COFFS HARBOUR HOSPITAL EXPANSION REFURBISHMENT

**FINISHES PLAN
GROUND LEVEL
EMU & ED STAFF**

PROJECT No	DRAWING No	REVISION
10492	MBA-63GF001	2

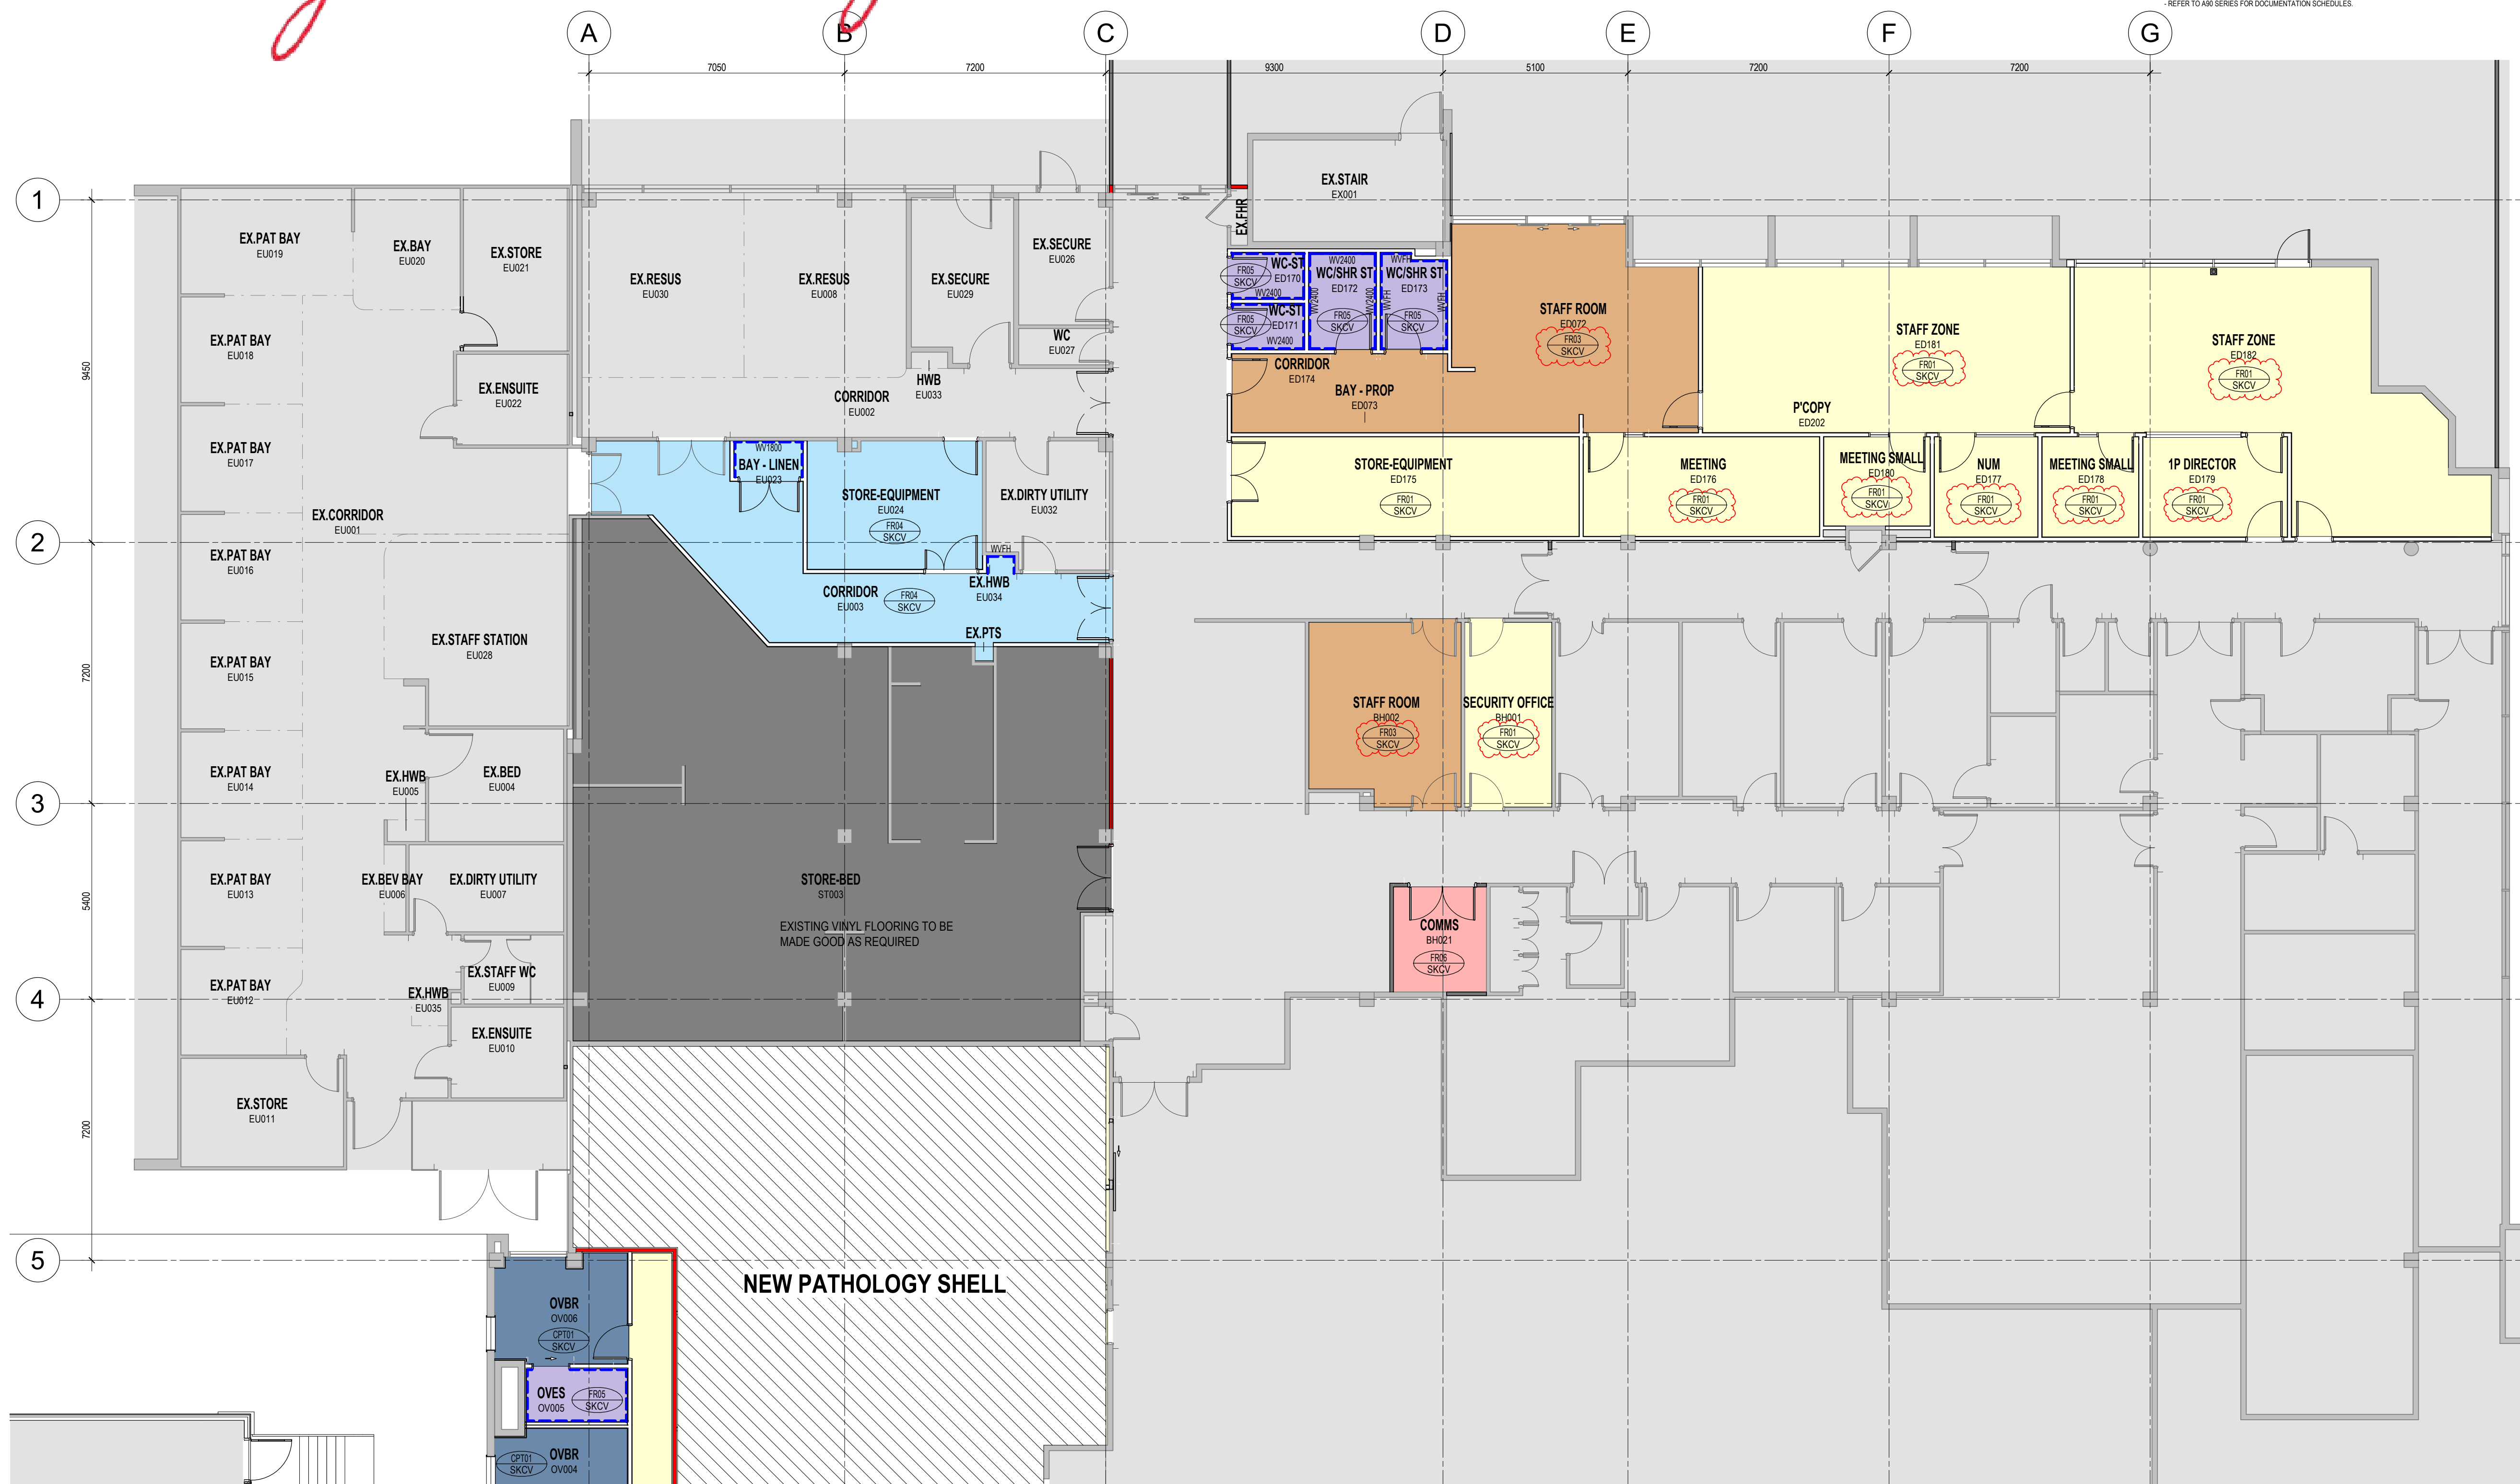
Variation 002 - no yet approved [14/16 weeks lead time]
now they add coving to FR01 - 170m2

plus TBC cove to timber vinyl locations
